Assessment report to **Sydney Central City Planning Panel**

Panel reference: PPSSCC-405

DA number SPP-22-00008 **Date of lodgement** 1 November 2022 **Applicant** Ali Hammoud **Owner** Illuminate NSW Limited Demolition of existing structures, tree removal, Stage 1 - erection of temporary demountable private school rooms and use of the existing house as an administration office and car park; Stage 2 - construction of part of a **Proposed** new private 3-storey primary school educational establishment over a development basement car park with associated excavation and earthworks, stormwater and landscaping works; Stage 3 - demolish demountable rooms and complete new school building and basement carpark Street address

39 Beames Avenue, Rooty Hill

ROOF PLAN
DA015	9
Sheet no.	Issue

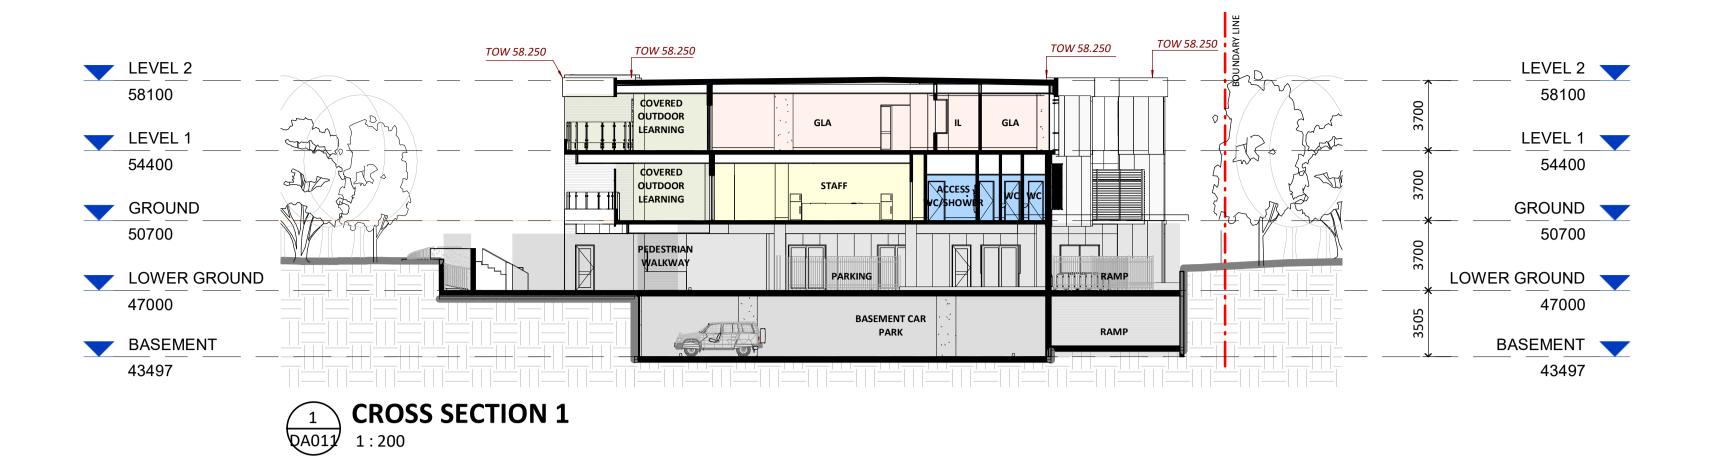
- 8.5.2 It is unclear how the lift will operate in the absence of a lift overrun on the rooftop. There is no lift mechanism indicated on the plans and this is usually located on the roof. The height exceedance would be more significant if this plant was included on the plans.

4 LONG SECTION 2 1:200

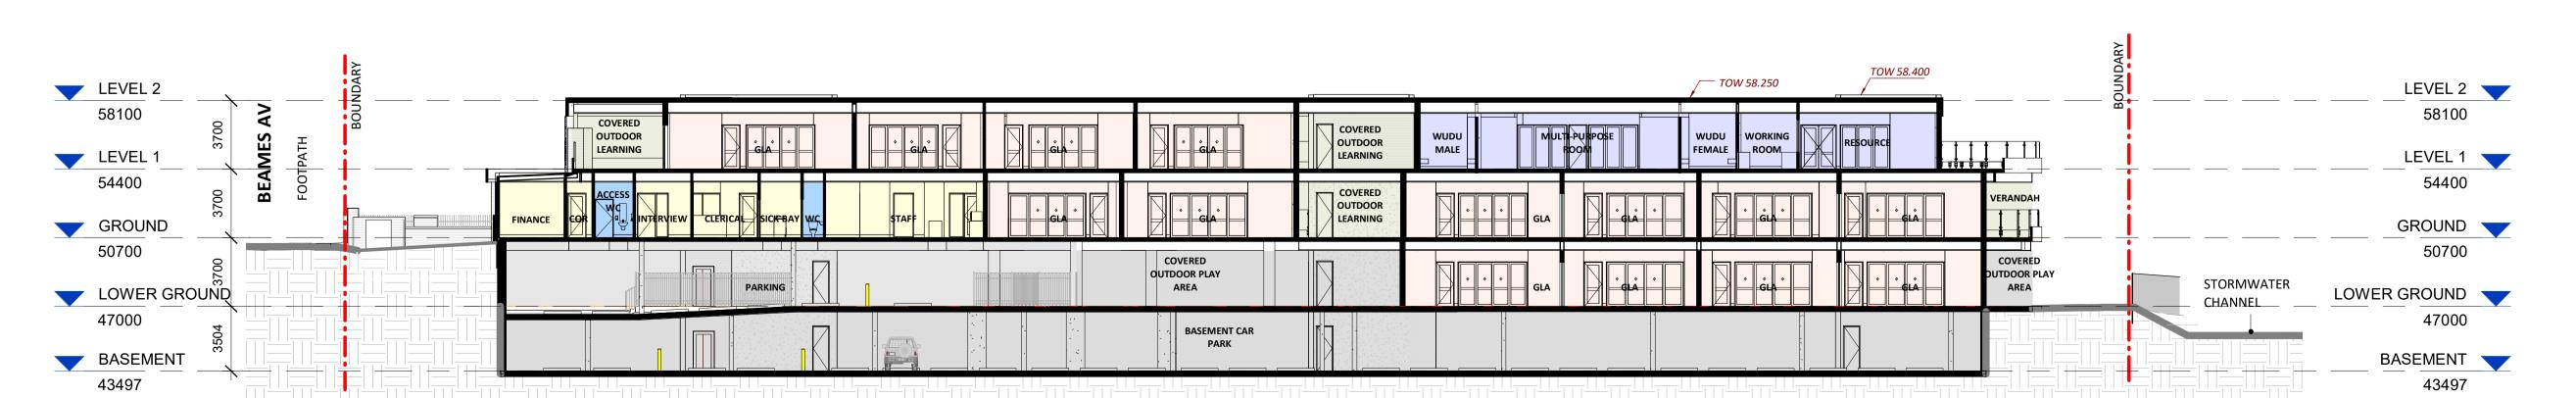
8.5.1 Blacktown Local Environmental Plan prescribes a 9m maximum building height for the site. Whilst the amended proposal has lowered the building by introducing basement car parking, the majority of the third floor remains above the height limit as indicated in orange below. Council only accepts rooftop plant and lift overruns to be above the height limit, but in this case all the rooms on the third floor that are associated with the school's operation are above the height limit. The building is still 2.6 m above the height limit according to the applicant's Clause 4.6 variation request.
